OCD-HOBBS
SUNDRY NOTICES AND REPORTS ON WELLS
Do not use this form for proposals to drill or to re-enter an abandoned well. Use form 3160-3 (APD) for such proposals.

1. Type of Well <input checked="" type="checkbox"/> Oil Well <input type="checkbox"/> Gas Well <input type="checkbox"/> Other		5. Lease Serial No. LC-063586
2. Name of Operator Cimarex Energy Co. of Colorado		6. If Indian, Allottee or Tribe Name
3a. Address 600 N. Marienfeld St., Ste. 600; Midland, TX 79701	3b. Phone No. (include area code) 432-571-7800	7. If Unit or CA/Agreement, Name and/or No.
4. Location of Well (Footage, Sec., T., R., M., or Survey Description) SHL 1140 FNL & 330 FEL 29-19S-32E BHL 660 FNL & 1650 FWL		8. Well Name and No. Southern California 29 Federal No. 18
		9. API Well No. 30-025-39889
		10. Field and Pool, or Exploratory Area Lusk; Bone Spring, S
		11. County or Parish, State Lea, NM

Location: Lea County, NM
Field: (SC) Sec 29, T19S, R32E
Facility: Southern California 29 Fed No. 18H

OPERATOR'S NAME:	Cimarex Energy Co. of Colorado
LEASE NO.:	NMLC-063586
WELL NAME & NO.:	Southern California 29 Federal #18
SURFACE HOLE FOOTAGE:	1140' FNL & 330' FEL
BOTTOM HOLE FOOTAGE:	330' FNL & 330' FWL
LOC

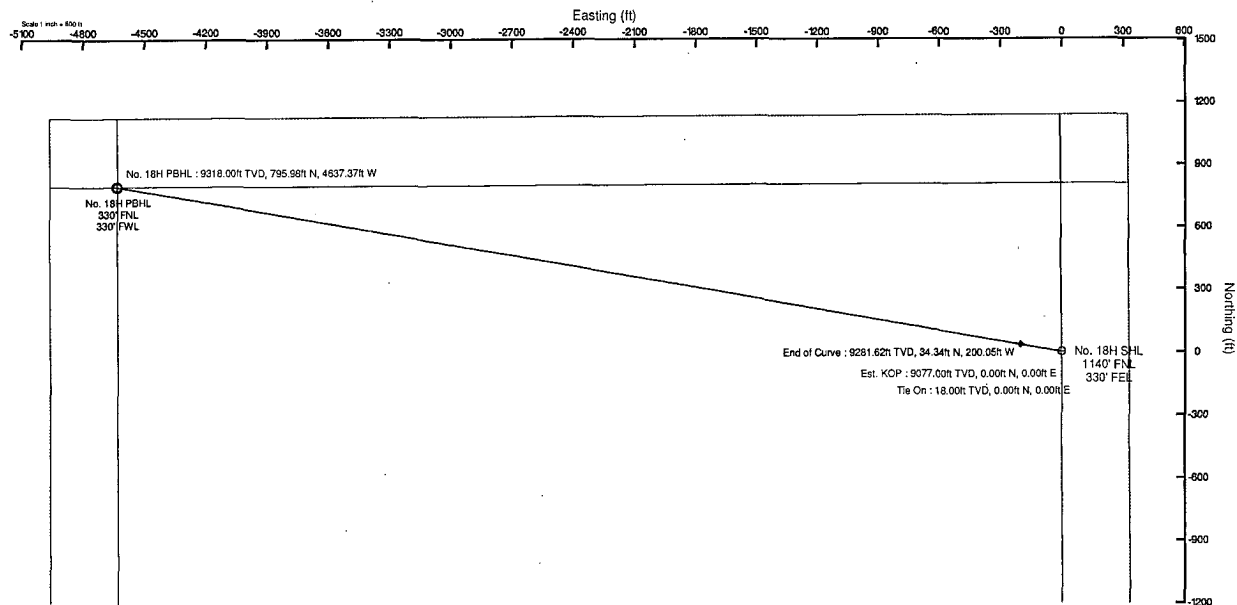
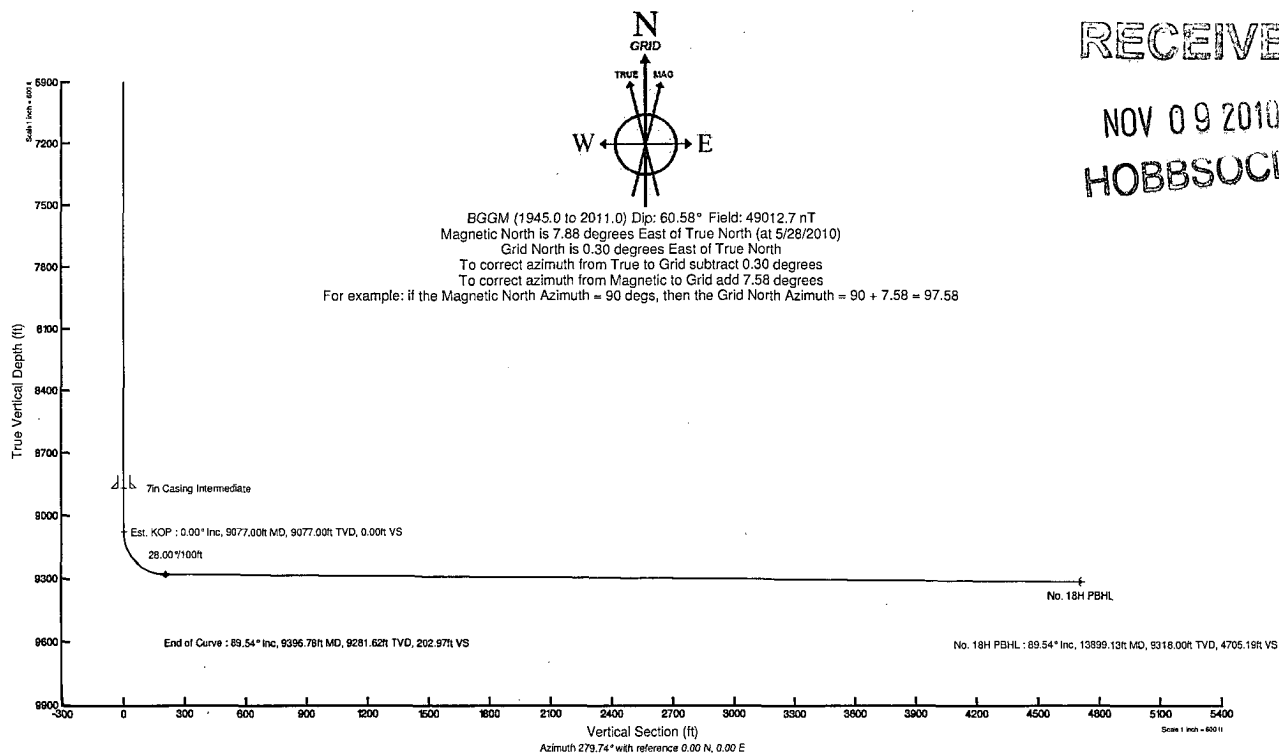
Cimarex is changing BHL for this well as shown below in order to contact more pay.

Permitted Location
SHL 1140 FNL & 330 FEL
BHL 660 FNL & 1650 FWL

New Proposed Location
SHL 1140 FNL & 330 FEL
BHL 330 FNL & 330 FWL

The well's permitted casing program includes 7" for production casing and a 4½" lateral string. Cimarex would like to change the production casing plans to 5½" from surface, through the curve, to TD as shown below, using 8.4-9.0 ppg FW/Brine:

Drill 8¾" hole to pilot hole depth of 9550' and log. Set kick off plug from 7897-9550' with 270 sx Prem Plus H (15.8, 1.19) and kick off @ 9077' and drill to TD @ 13899.' Run 5½" 17# P-110 LTC from 0-13899.' Cement with Lead 500 sx EconoCem + 5lbm/sk Gilsonite 2.48 cf/sk 11.9 ppg and Tail 1760 sx Halcem 15.6 ppg 1.19 cf/sk TOC 3500'

3. The minimum required fill of cement behind the 5-1/2 inch production casing is:

- ☒ Cement should be at least 50 feet above the top of the Capitan Reef. Operator shall provide method of verification. **Additional cement may be required as the excess calculates to less than 25%.**

5 1/2 casing inside the 9 5/8					Design Factors		PRODUCTION		
Segment	#/ft	Grade	Coupling	Joint	Collapse	Burst	Length	Weight	
"A"	17.00	P 110	LT&C	1.11	1.31	2.38	13,899	236,283	
"B"							0	0	
"C"							0	0	
"D"							0	0	
w/8.4#/g mud, 30min Sfc Csg Test psig: 2,050							Totals:	13,899 236,283	
A	Segment	Design	Factors	would be:	2.81	1.72	if it were a vertical wellbore.		
<u>The cement volume(s) proposed may achieve a top</u>					<u>2800</u>	<u>feet from surface.</u>			
Hole Size	Annular Volume	Proposed Sx Cmt	CuFt Cmt Proposed	Min Cu Ft	Excess % Cmt	Drilling Mud Wt	Calc MASP	Req'd BOPE	Min Dist Hole-Cplg
8 3/4	0.2526	2260	3334	2819	18	9.00			1.35
Sundry to do away with the 7" production casing & 4-1/2" liner and use 5-1/2 casing from 0-TD and cemented back to 50' above the top of the Capitan Reef. The BHL will be changed to 330'FNL & 330'FWL from 660'FNL & 1650'FWL before.
